General Service Bulletin

HCOM-SB-85

35-60 Ton Helical Rotary Compressor Motor Terminal Retrofit

Figure 1. Description of Motor Terminal Insulator Retrofit

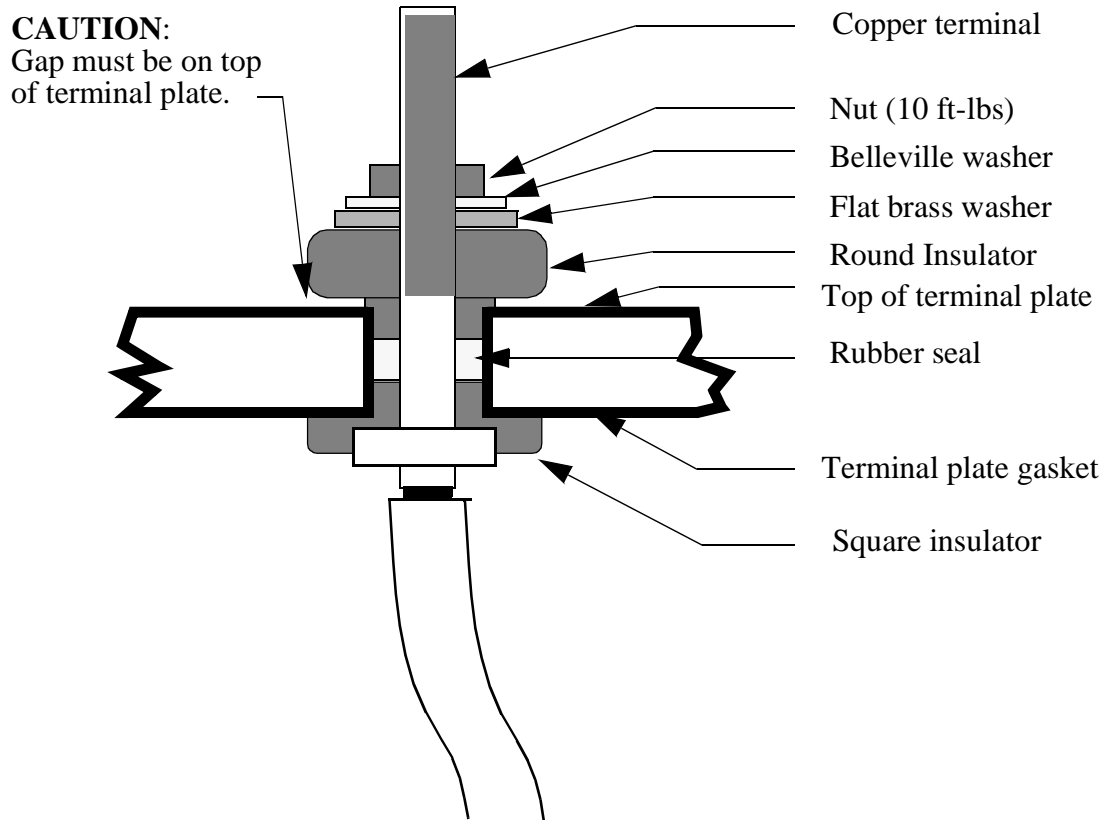
The original insulators used on the 35-60 ton helical rotor compressor motor terminals may leak due to slight variations in the terminal plate. Rather than re-designing the terminal plate, the motor terminal stud insulators were re-designed to be more tolerant of variations in the terminal plate.

The original insulators were also installed with steel nuts and washers. If the compressor is located in an environment with high humidity the steel nuts and washers will rust. The rust can travel down the terminal and across the insulator. This path can cause the compressor to short to the terminal plate.

1. With the power disconnected and all refrigerant removed from the compressor, loosen the nuts securing the insulators to the terminals.
2. Remove the 12 terminal plate mounting bolts.
3. Remove the nuts, washers and upper insulators from the motor terminal.
4. Carefully tip the terminal plate up so the motor temperature sensors can be disconnected.

5. Remove the terminal plate.
6. Inspect components for scratches, etc. that may cause a leak.
7. Remove lower insulator.
8. Begin reassembly by replacing lower insulators

- (green) with the square black insulator making sure the terminal post is seated in the insulator.
9. Replace o-rings with the rubber seal.
10. Oil and install new terminal plate gasket.
11. Carefully push terminals through the terminal plate.

12. Install upper insulator (round, black).
13. Place flat brass washer on top of the upper insulator.
14. Place belleville washer on top of the flat brass washer such that the outside edges of the belleville touch the flat washer.
15. Hand tighten the nut. Do not exceed 10 ft.-lb. on the nut. Refer to Figure 1 for the assembly of the new insulators.
16. Reconnect the spade connectors for the motor temperature sensors. Follow the color coding of the sensors.
17. Install the terminal plate on the compressor with the 12 mounting bolts. Follow the torquing sequence as shown in Figure 2.
18. Torque the terminal plate mounting bolts to 40 ft.-lb.
19. Torque the terminal stud nuts to 10 ft.-lb.
